# DISCUSSION MEMO

**Date:** August 27, 2021  
**To:** Portland Design Commission  
**From:** Benjamin Nielsen, Design / Historic Review Team  
(503) 865-6519, [benjamin.nielsen@portlandoregon.gov](mailto:benjamin.nielsen@portlandoregon.gov)  
**Re:** West Portland Town Center Character Statement  
Briefing Memo – September 2, 2021

**Re:** BDS Comments on West Portland Town Center Plan – Preliminary Proposed Draft

*Approximate boundary of proposed design overlay zone.*

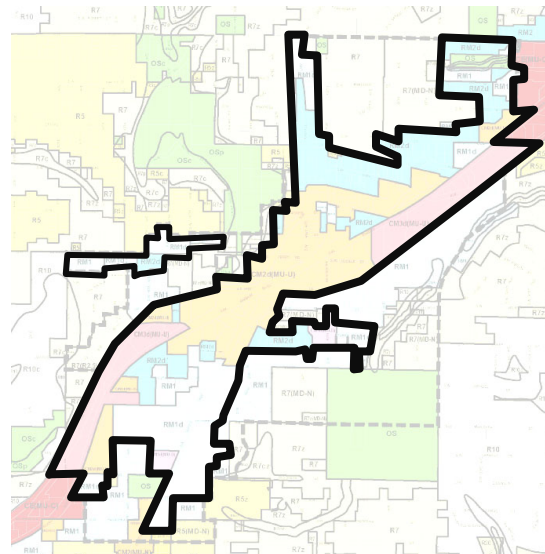
The Design Commission may be most interested in the expansion of the “d” design overlay zone and upzoning of low-density residential properties within the WPTC. Currently, the design overlay zone hugs SW Barbur Blvd and lies only on commercially-zoned properties.
